Meath County Council Newtown Trim Active Travel Scheme

DMURS Quality Report (Including Stage 1/2 Road Safety Audit)

Newtown Road Trim Active Travel Scheme

Road Safety Audit - Stage 1-2

Figure 2-1 Pedestrian Desire Line with existing stone wall (Dwg No. 11587-2420-D02)

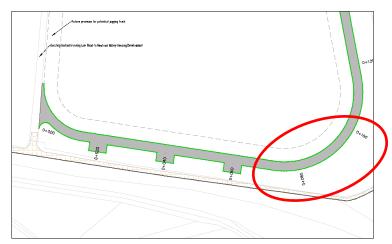
Pedestrian Connectivity

The Audit Team note no link is proposed between the existing and proposed footway at the desired crossing point of the Old Lackanash Road. The Audit Team are concerned that pedestrians may jump from the proposed footpath onto the existing footway over the stone boundary wall. This dangerous behaviour, in close proximity to the live carriageway, may result in a collision between a VRU and a vehicle.

The design team should provide a link from the proposed footpath to the footway at the desire line.

Figure 2-3 Existing / Proposed Footway (Dwg No. 11587-2420-D02)

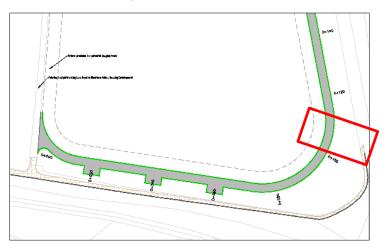
Footway Existing / Proposed Connectivity to Amenity

The Audit Team noted the proposed footpath does not link to the existing footway. The Audit Team observed the trip attraction of "Regans" on the opposite corner of the junction. The Audit Team are concerned that the pedestrians, in lieu of designated connection, will create a tracked and unpaved connection to the existing footway. This may result in a trip hazard for pedestrians.

The design team should provide a footpath on the desire line between the existing and proposed infrastructure.

Figure 2-4 Termination of Footway - Incorrect Tactile Paving (Dwg No. 11587-2422-D02)

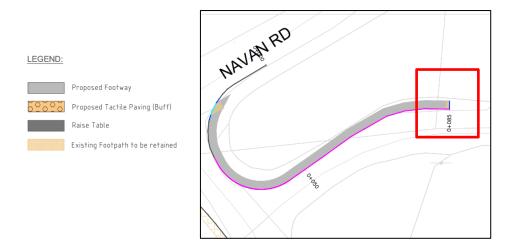
End of Footway - Tactile Paving

The Audit Team noted at the end of the footway tactile paving is proposed. The Audit Team are concerned that the tactile provision is the blister buff tactile, which represents an uncontrolled crossing. Incorrect tactile paving may result in confusion to those with visual impairments. This may result in a VRU entering the carriageway in conflict with a vehicle / trip hazard within the grass verge.

The design team should provide appropriate tactile paving at the termination of the footway.
